AGENDA
Design Review Committee
August 10, 2022 – REGULAR MEETING
5:30 PM

Town of Jackson Design Guidelines Checklist

Item Number: P22-163

Address: 345 W. Broadway Ave.

PROPOSED
SOUTH ELEVATION

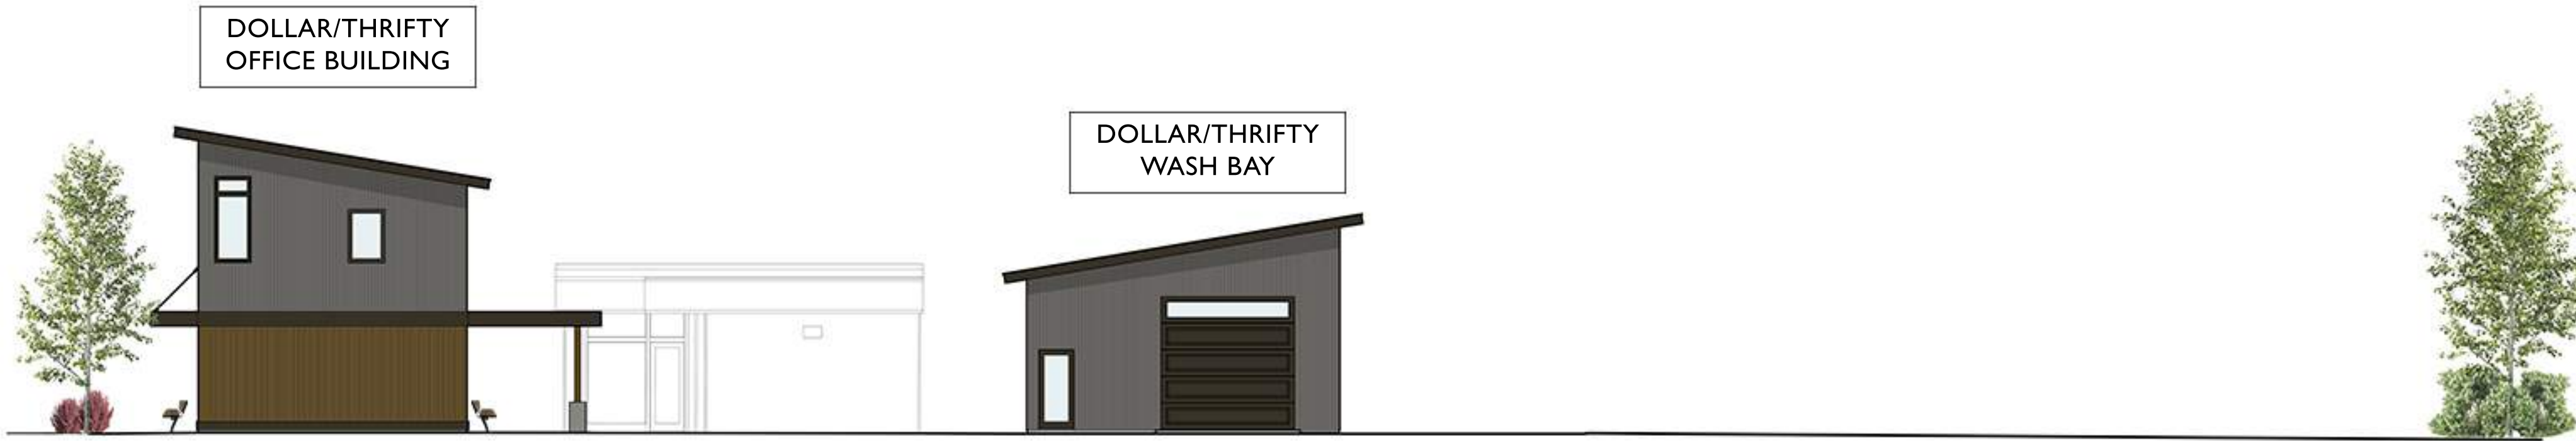
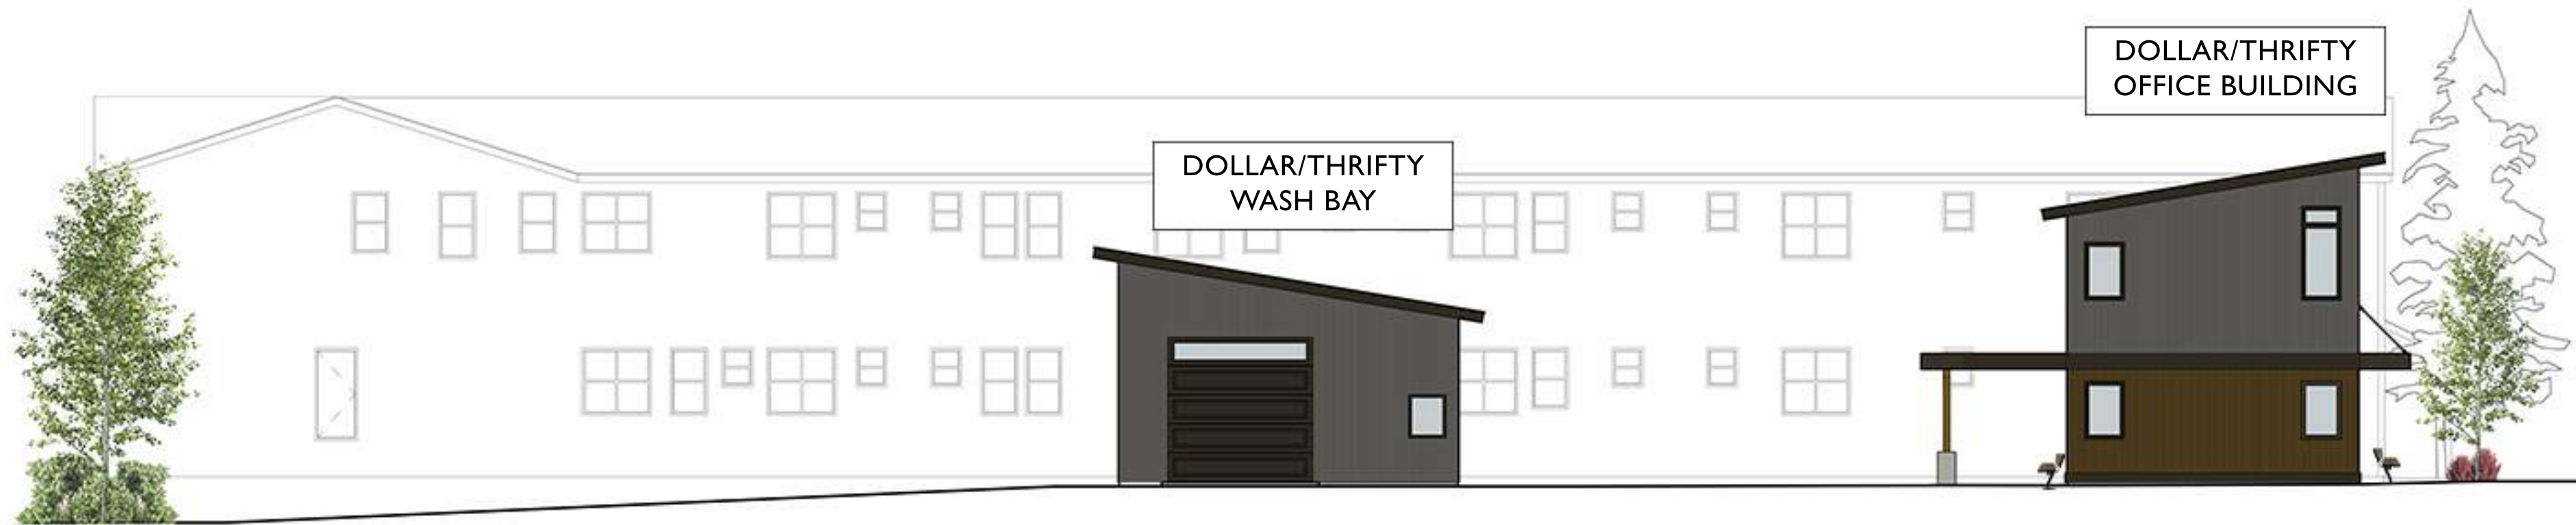
2. The ground level of the building should be modified so that it better relates to the pedestrian experience. The applicant suggested a change in the material on the first level below the canopy that enhances the pedestrian experience making it more welcoming.

Applicant's Response: The applicant changed the exterior material on the ground level from corrugated metal to vertical wood siding (weathered dark gray/brown). The vertical wood siding wraps around the entire building and lines up with the elevation of the entry canopy.

2 SOUTH-EAST ELEVATION (APPROVED)
SCALE: 3/16" = 1'-0"

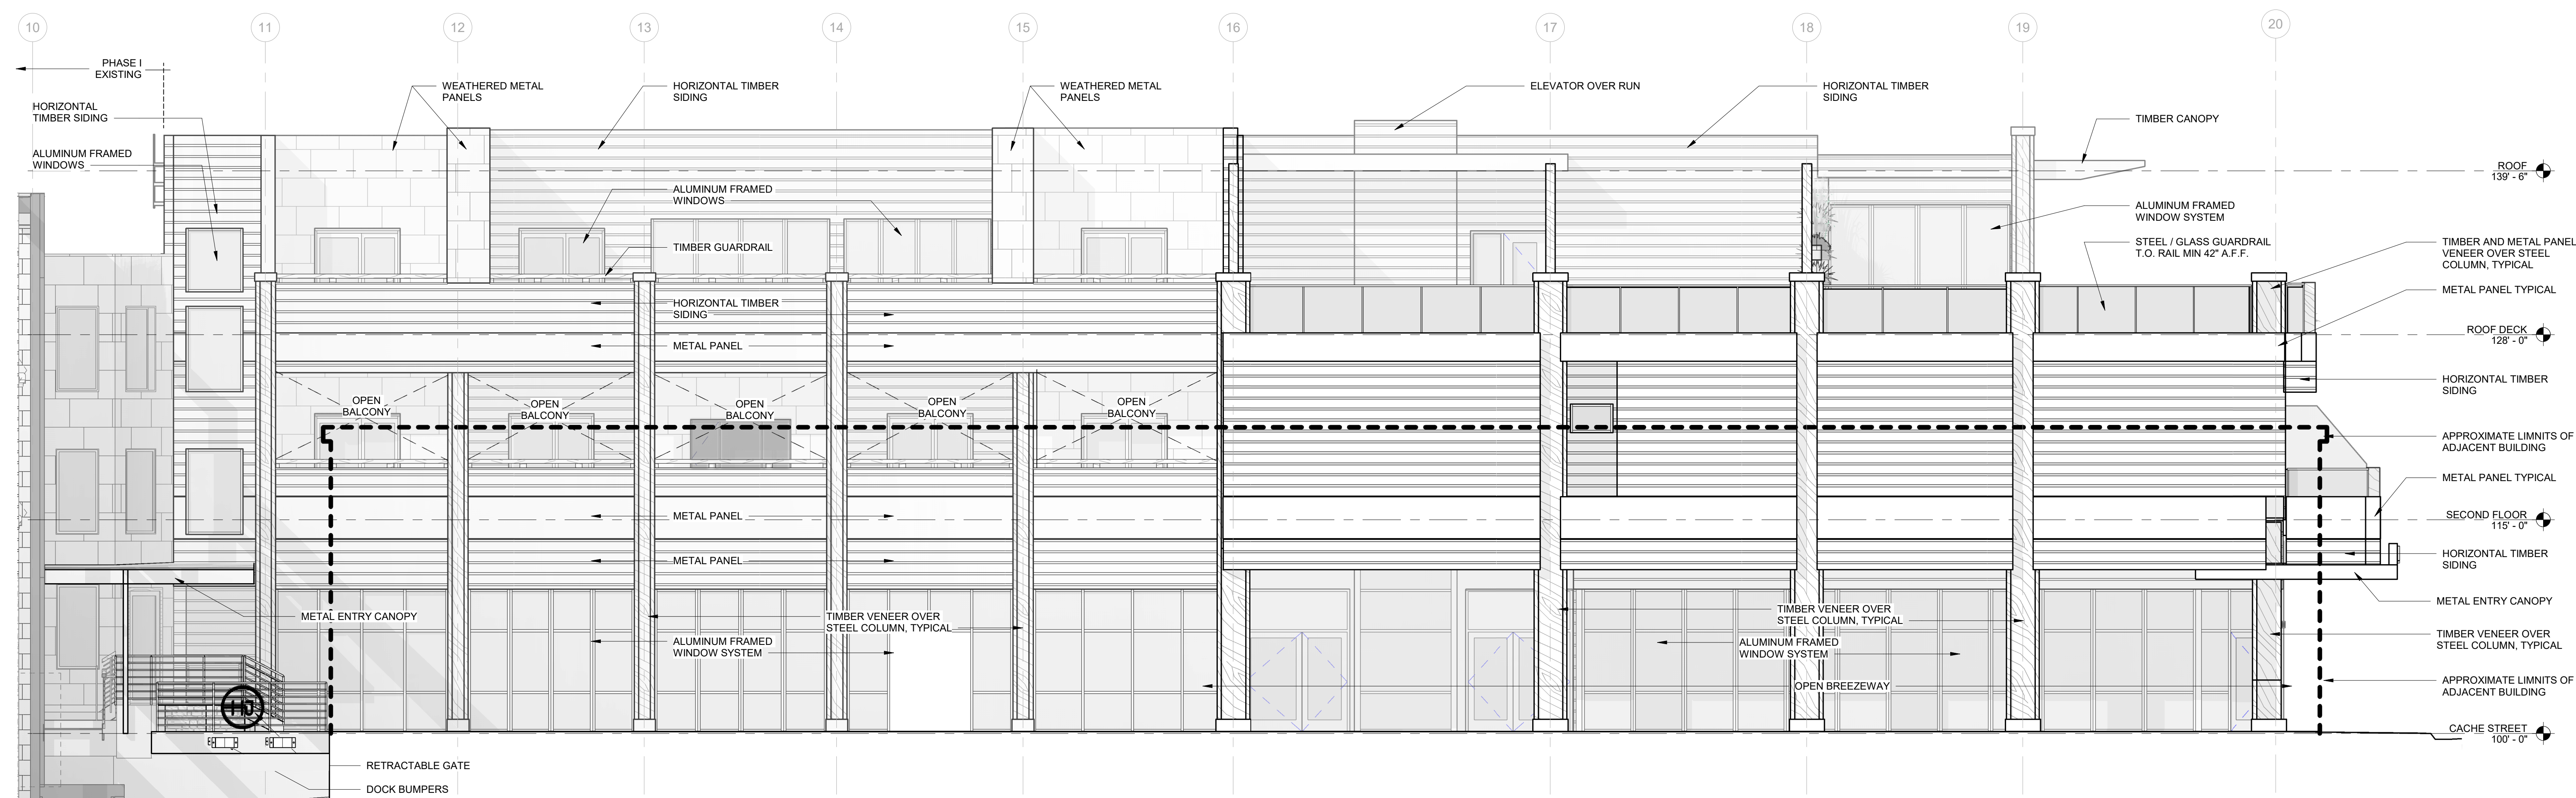
Staff Comments: Staff would like to point out that the design presented at the July 13th DRC meeting had a kick-plate along the North Cache ground level elevation which is in line with the Western Character Design Guidelines. In this most recent design change, the kick-plate was removed and replaced with floor-to-ceiling windows. This is not in line with the Western Character Design Guidelines.
